RE: Beehive Homes- Phase 4
13440 Wenonah
Engineer's Stamp Date: 9/25/17
Hydrology File: L23D022

Based on the information provided in your submittal received on 9/27/17, the Grading Plan is approved for Building Permit with the following condition:

PHASE IV GRADING AND DRAINAGE PLAN

BEEHIVE HOMES PHASE IV GRADING & DRAINAGE PLAN

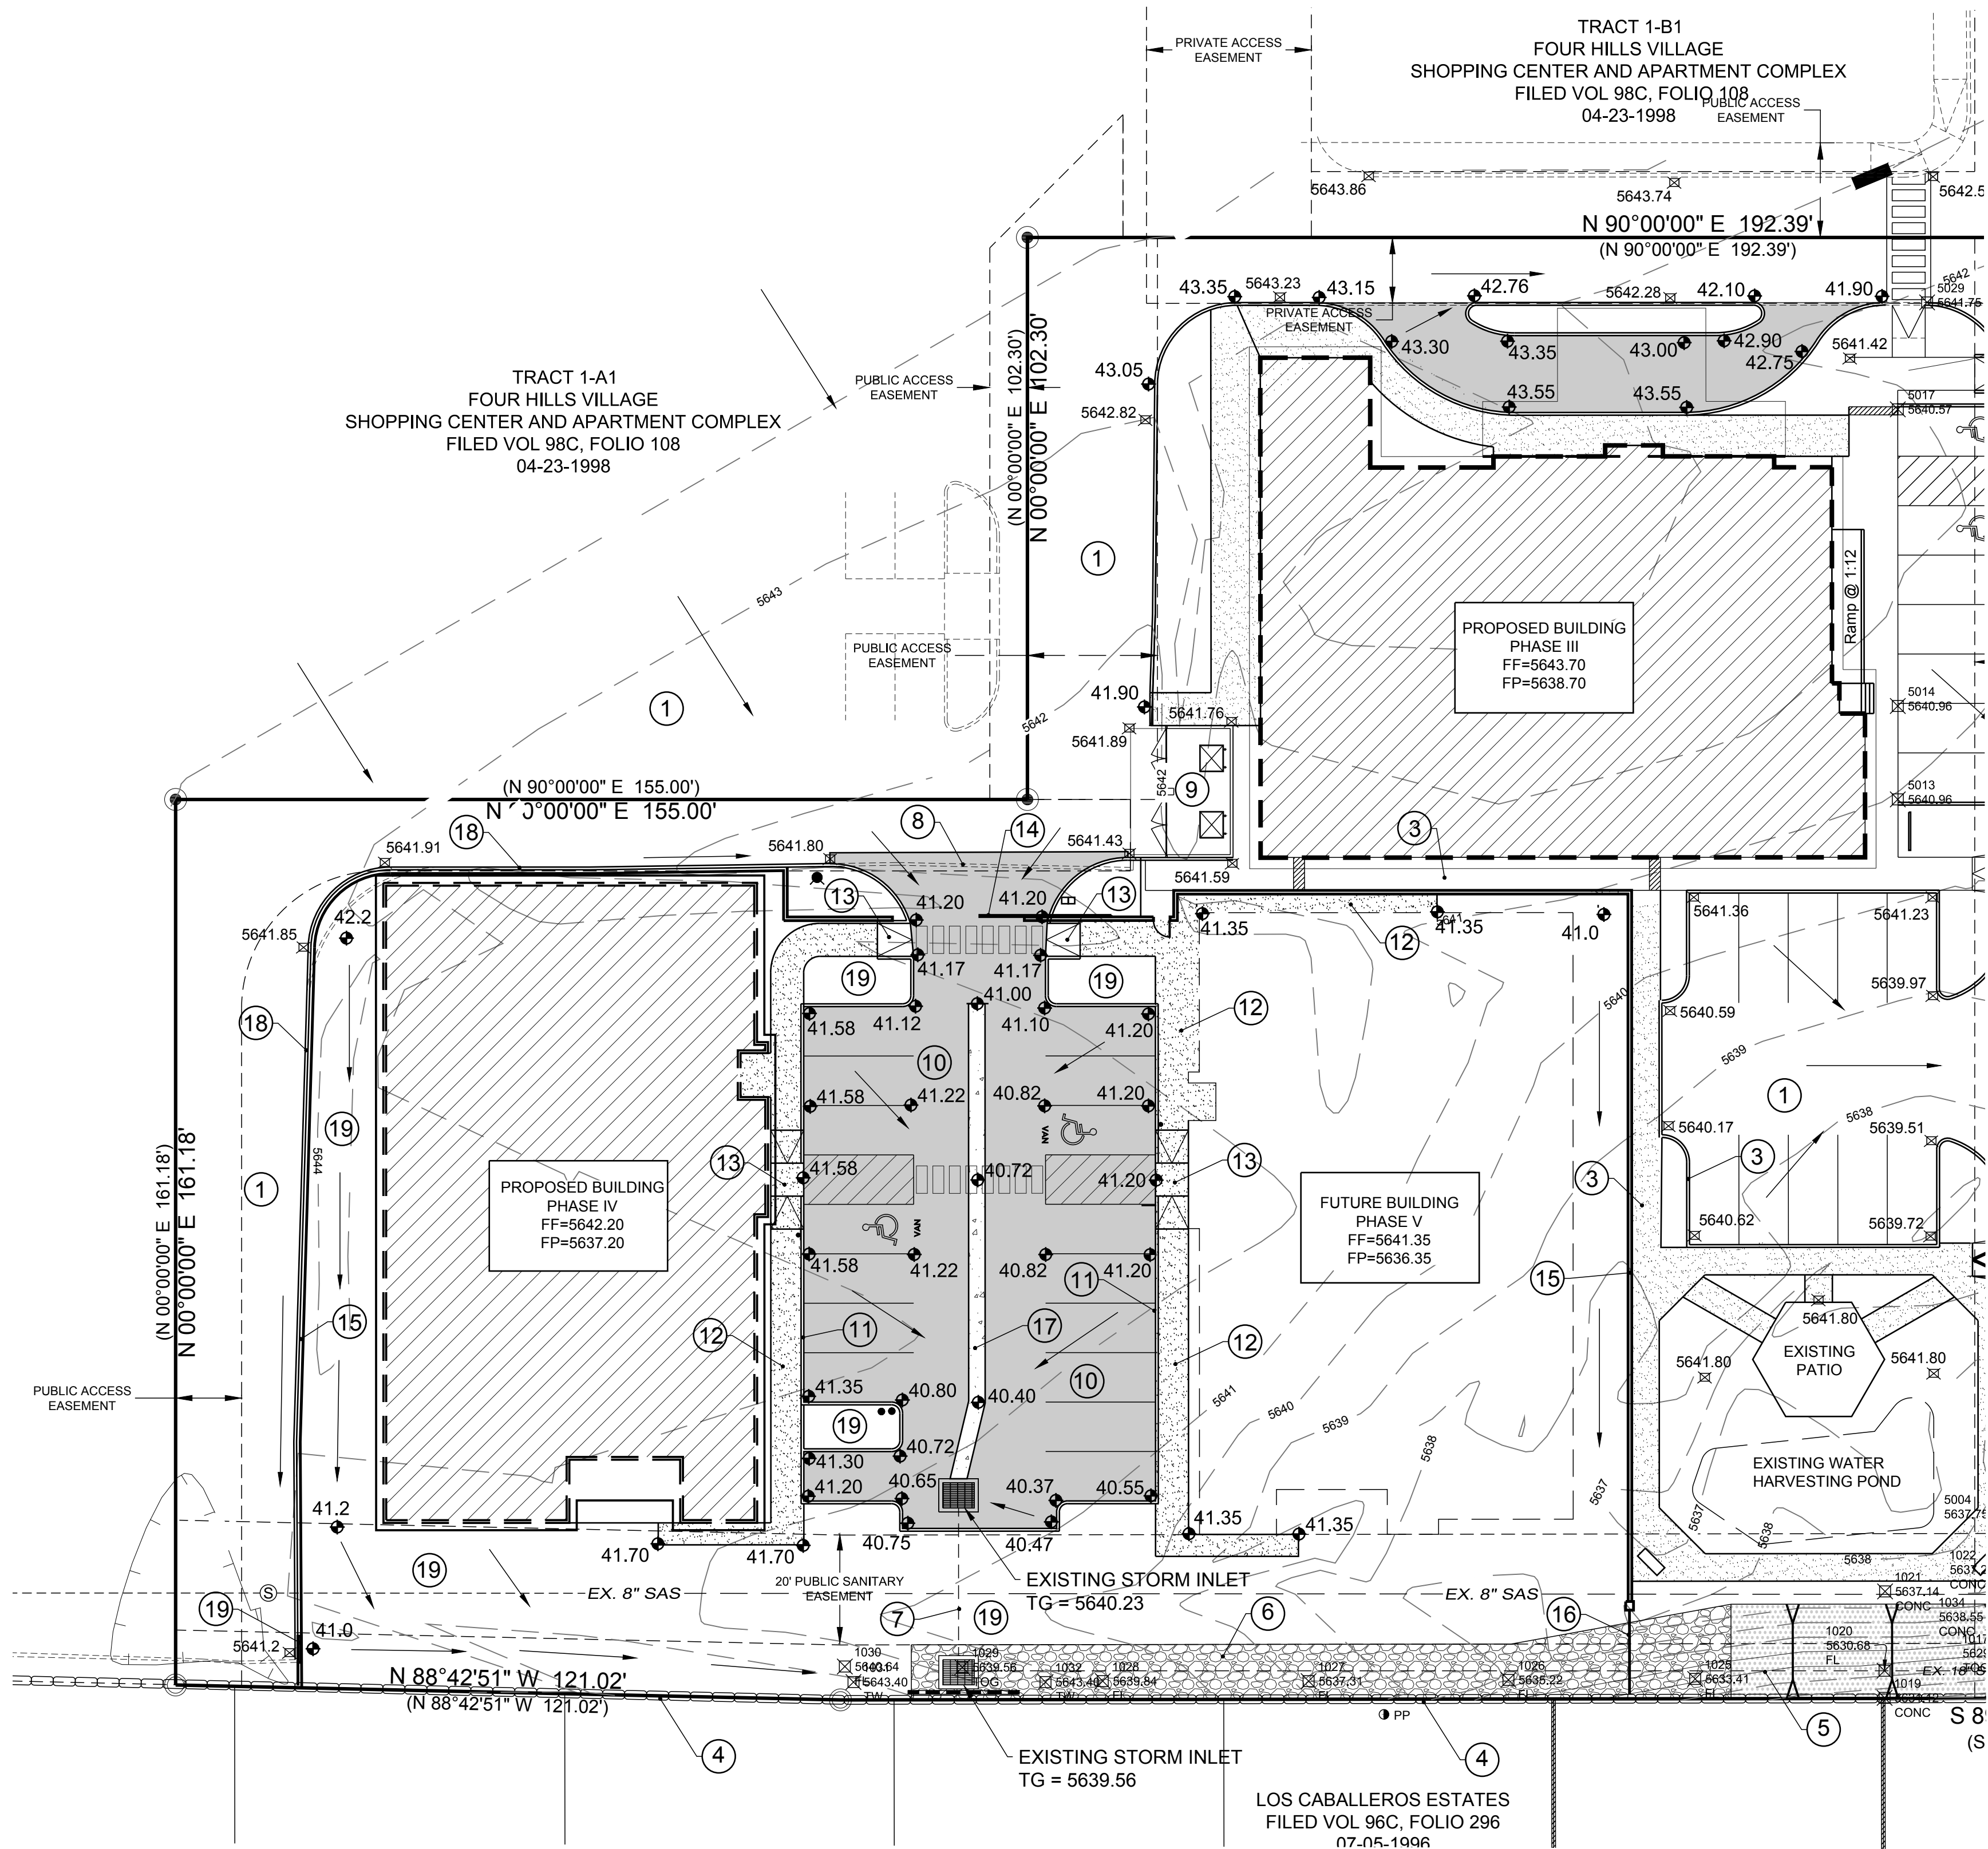
1. Prior to Hydrology Final Inspection for C.O., the sedimentation pond adjacent to Tramway Channel must be recertified, and will likely need to have sediment removed to restore bottom of pond to 5615'.
